Administrative Committee for the TIR Convention, 1975

Amendment proposals to the Convention: Vehicles with sliding sheets

Note by the secretariat

Amendment proposals for adoption by the Administrative Committee for the TIR Convention

Sketch No. 9.4

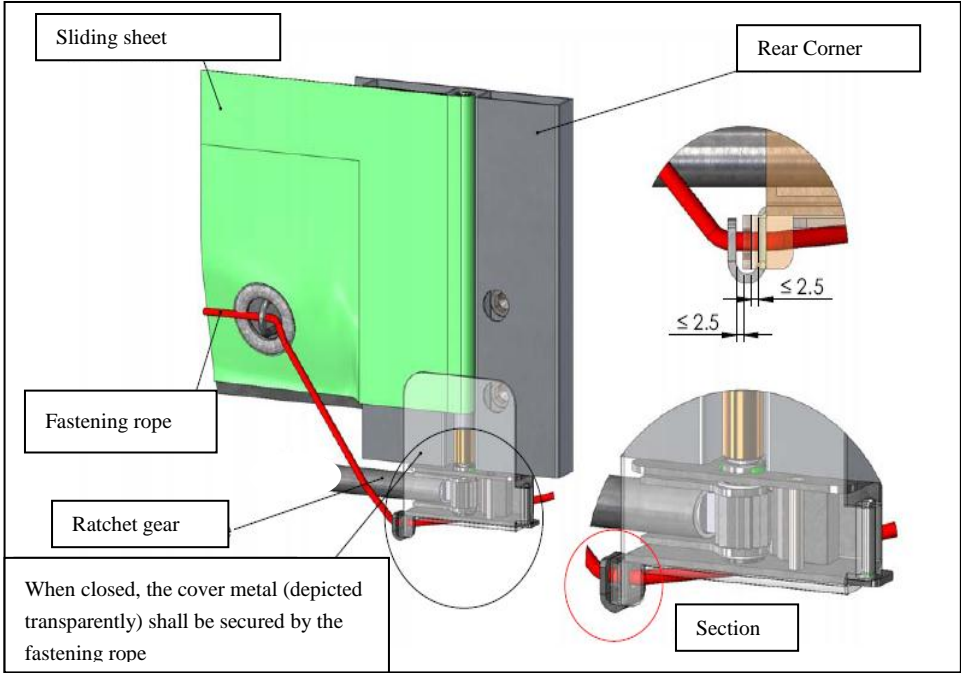
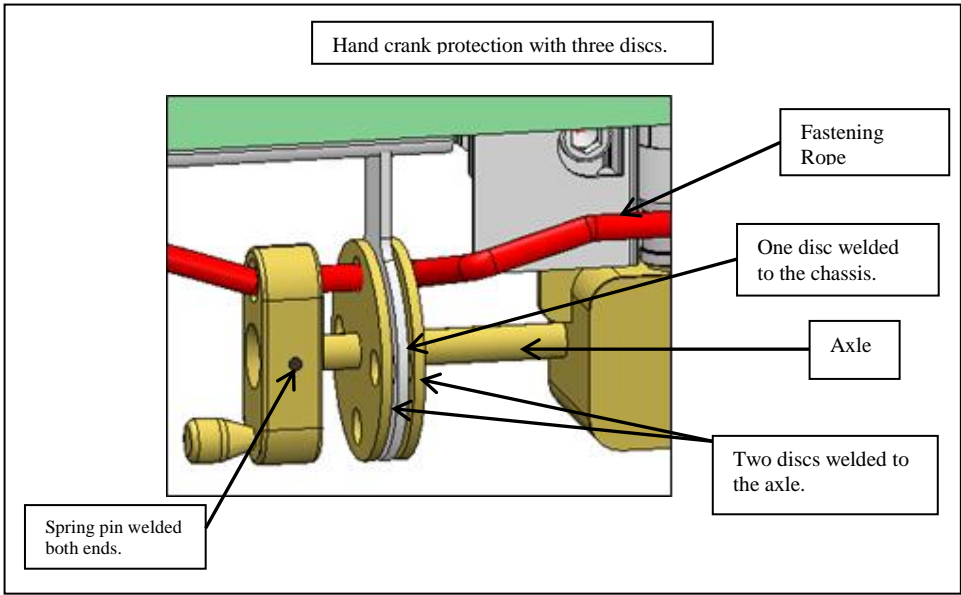
For the existing Sketch No. 9 *substitute*

To tighten the sliding sheets in the horizontal direction, a ratchet gear is used (normally at the rear end of the vehicle). This sketch shows two examples, (a) and (b), of how the ratchet or gearbox may be secured.

Sketch No. 9.5

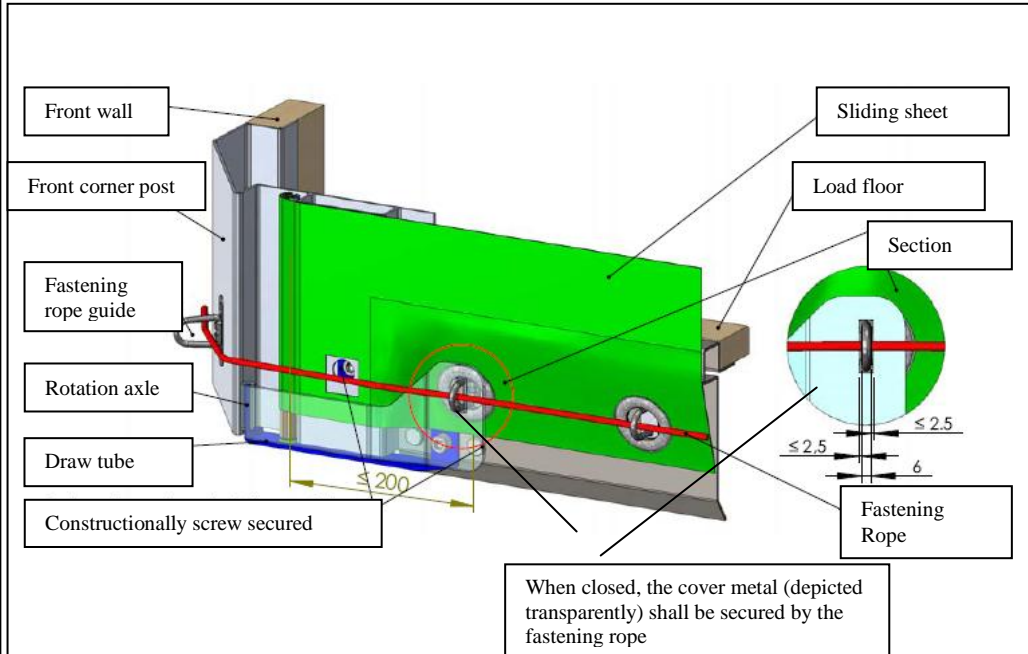
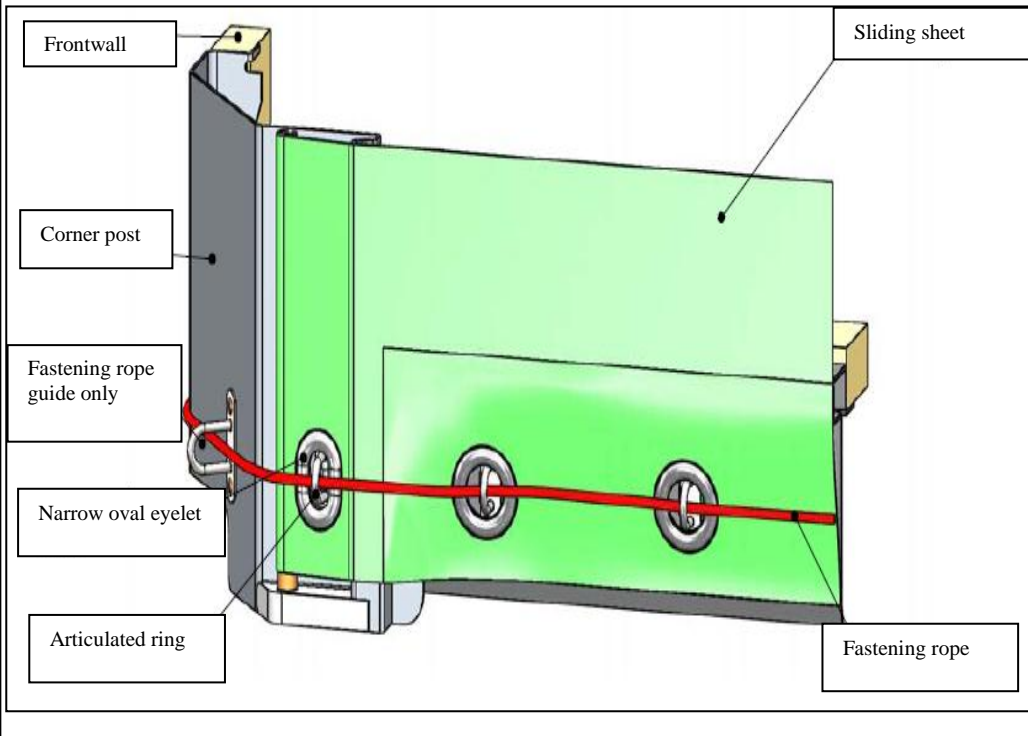
To fix the sliding sheet on the other side (normally the front of the vehicle), the following systems, (a) or (b), may be used.

Sketch No. 10

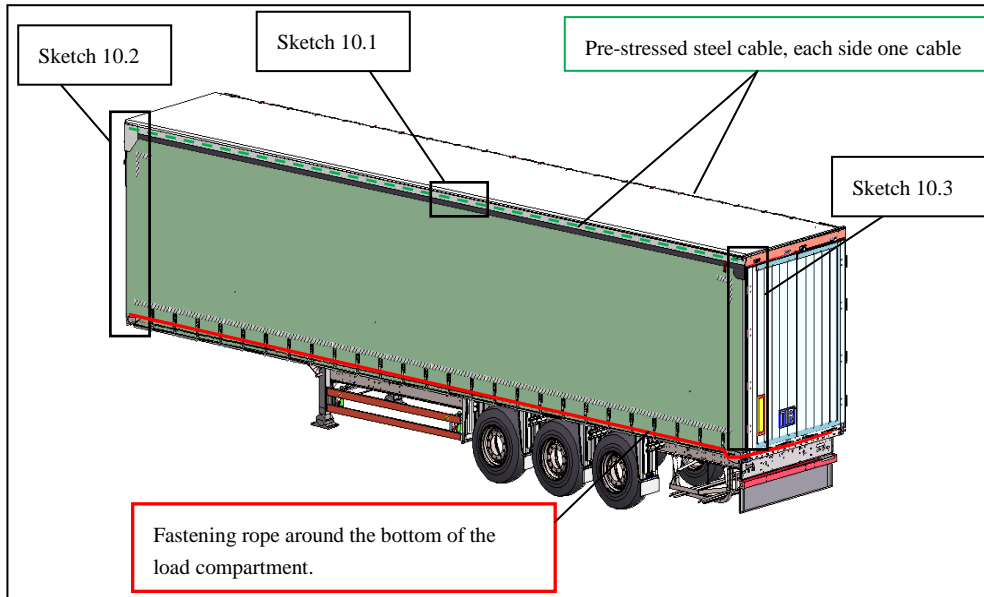
After new Sketch No. 9 insert

This sketch shows an example of a vehicle and the important requirements described in Article 5 of these Regulations.

Sketch No. 10.1

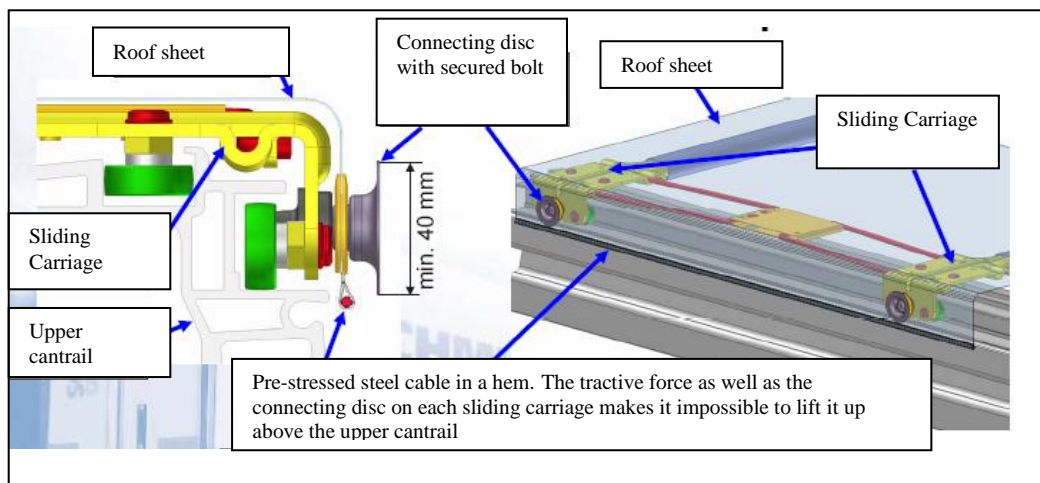
Two pre-stressed steel cables, embedded in a hem, are fixed on each side of the load compartment. This pre-stressed steel cable is fixed to the front (see sketch 10.2) and rear of the body (see sketch 10.3). The tractive force as well as the connecting disc on each sliding carriage makes it impossible to lift up the hem with the pre-stressed steel cable above the upper cantrail.

Sketch No.10.2

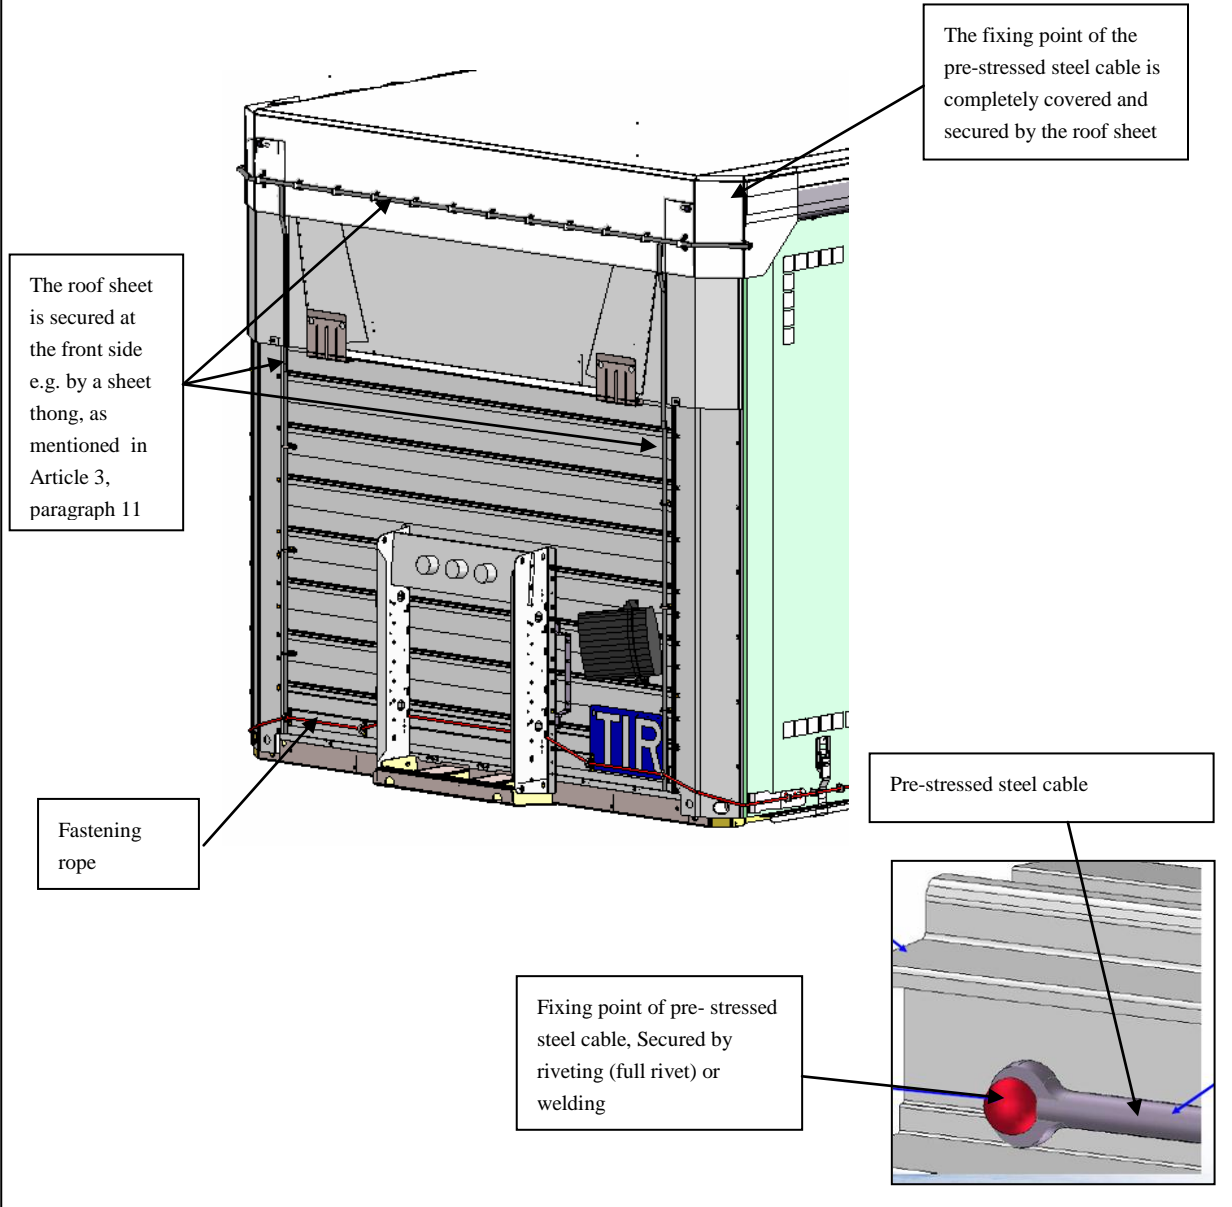
The sliding roof sheet shall overlap with the solid part of the roof at the front side of the load compartment, so that the roof sheet cannot be pulled over the top edge of the upper cantrail.

Sketch No.10.3

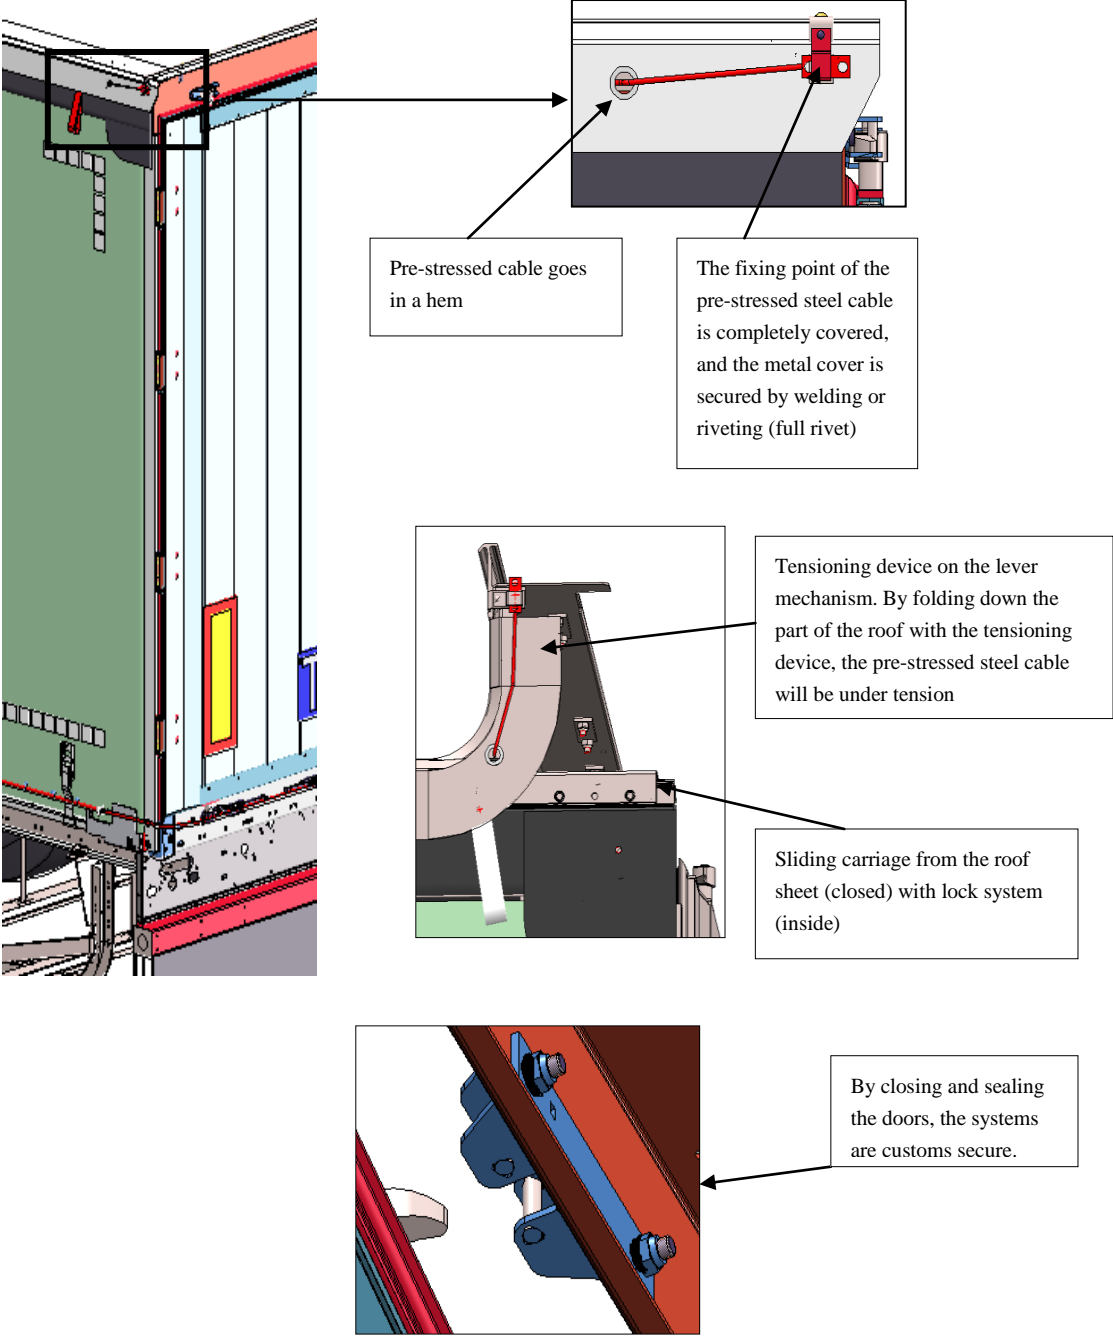
At the rear, a special device, such as a baffle plate, is fitted to the roof, preventing access to the load compartment, without leaving obvious traces when the doors are closed and sealed.

Sketch No. 9.4

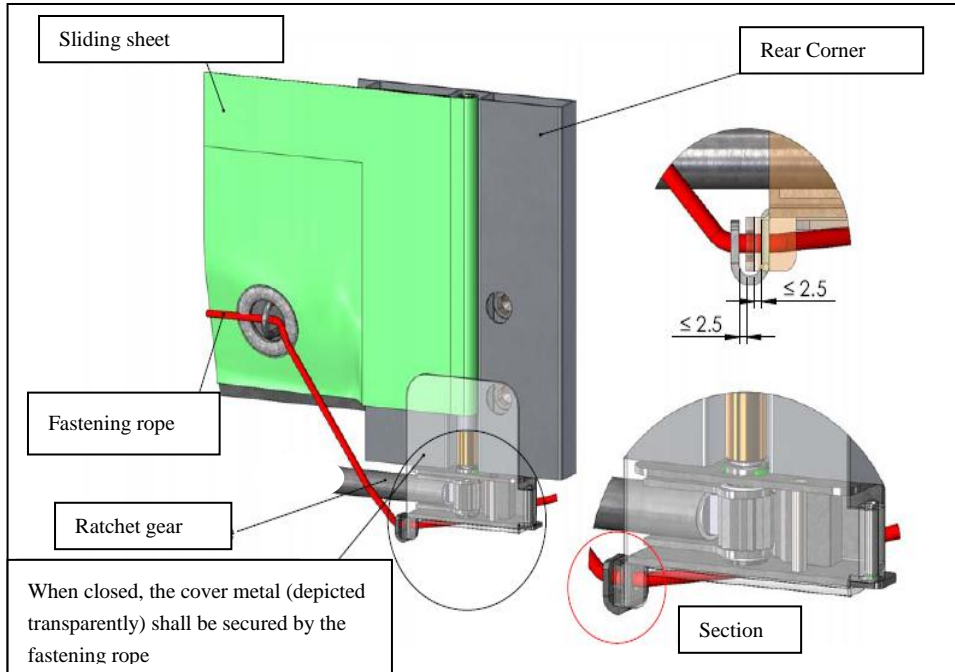
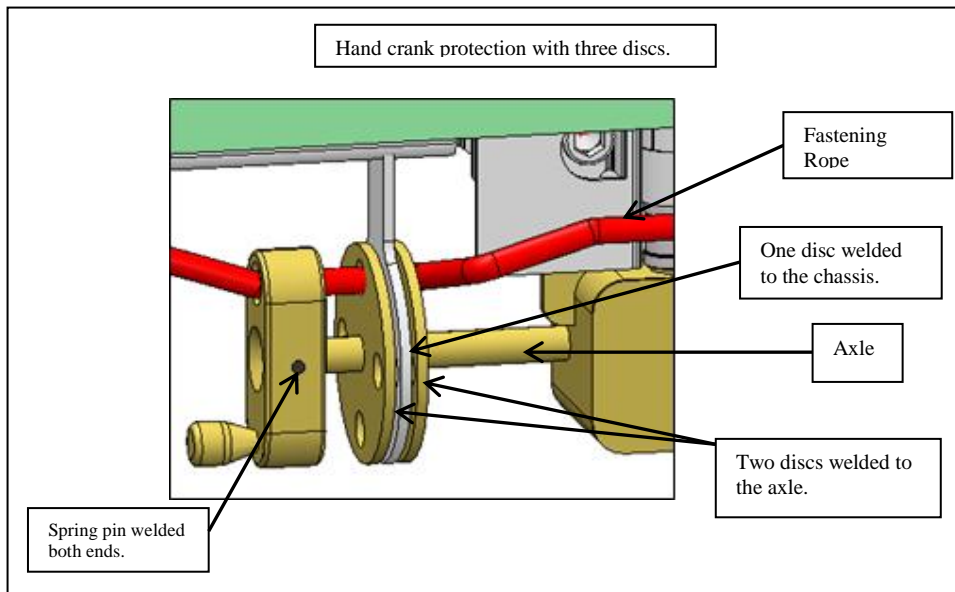
For the existing Sketch No. 9 substitute

To tighten the sliding sheets in the horizontal direction, a ratchet gear is used (normally at the rear end of the container). This sketch shows two examples, (a) and (b), of how the ratchet or gearbox may be secured.

Sketch No. 9.5

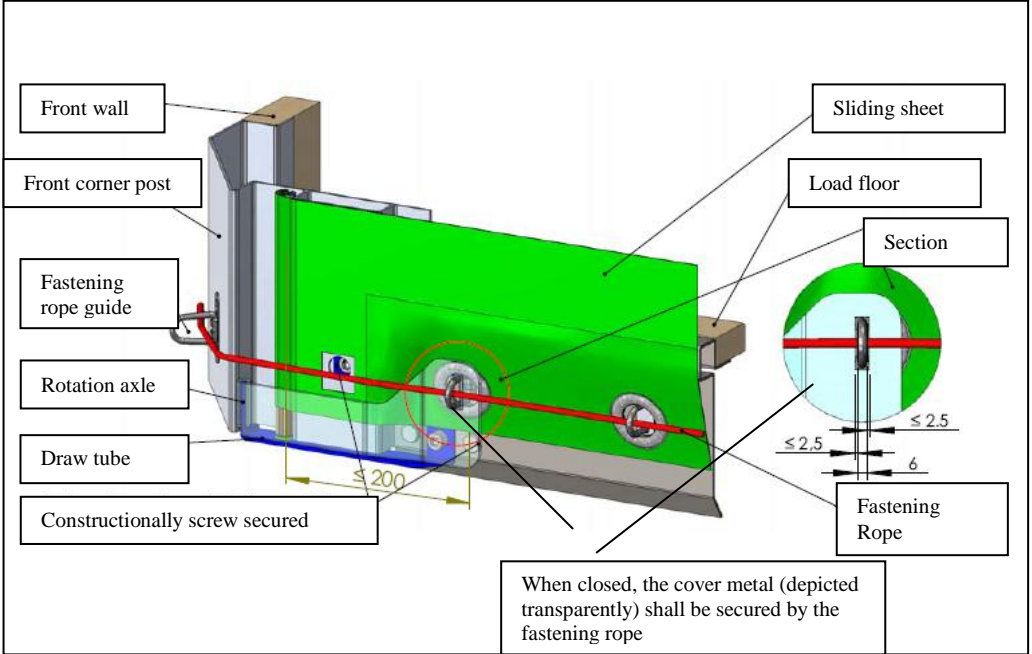
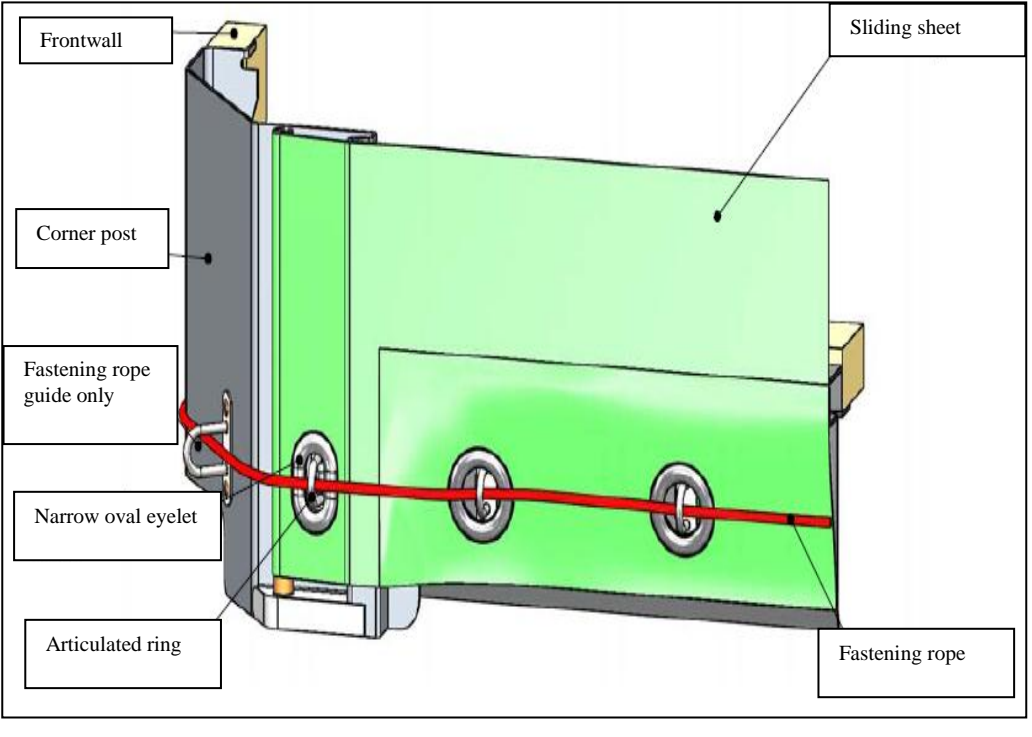
To fix the sliding sheet on the other side (normally the front of the container), the following systems, (a) or (b), may be used.

Sketch No. 10

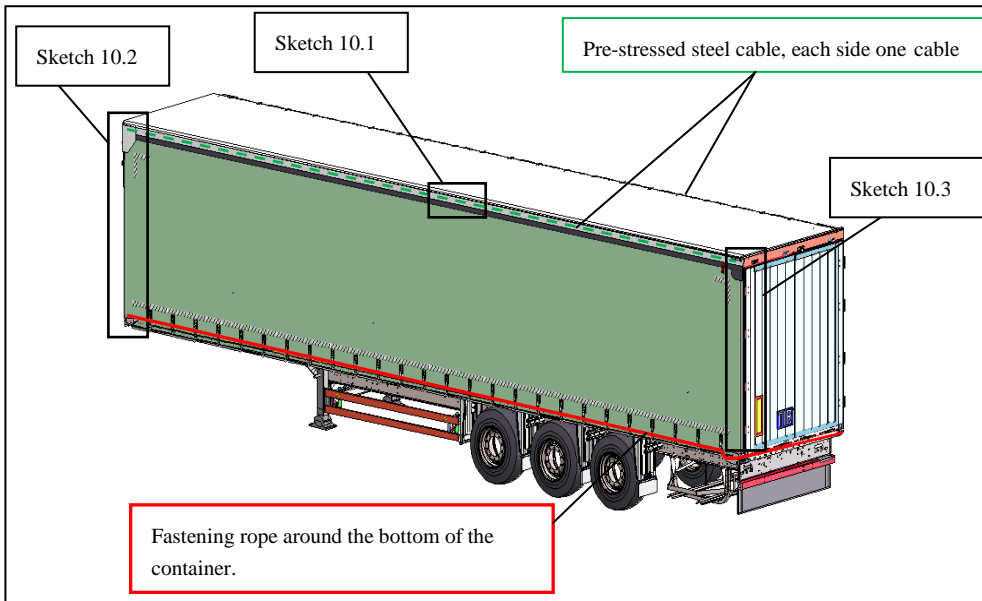
After new Sketch No. 9 insert

This sketch shows an example of a container and the important requirements described in Article 6 of these Regulations.

Sketch No. 10.1

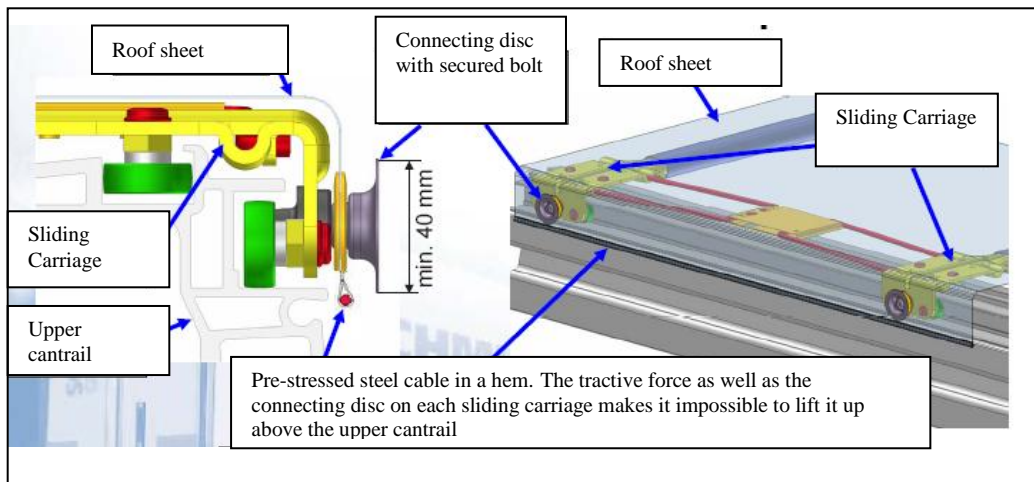
Two pre-stressed steel cables, embedded in a hem, are fixed on each side of the container. This pre-stressed steel cable is fixed to the front (see sketch 10.2) and rear of the body (see sketch 10.3). The tractive force as well as the connecting disc on each sliding carriage makes it impossible to lift up the hem with the pre-stressed steel cable above the upper cantrail.
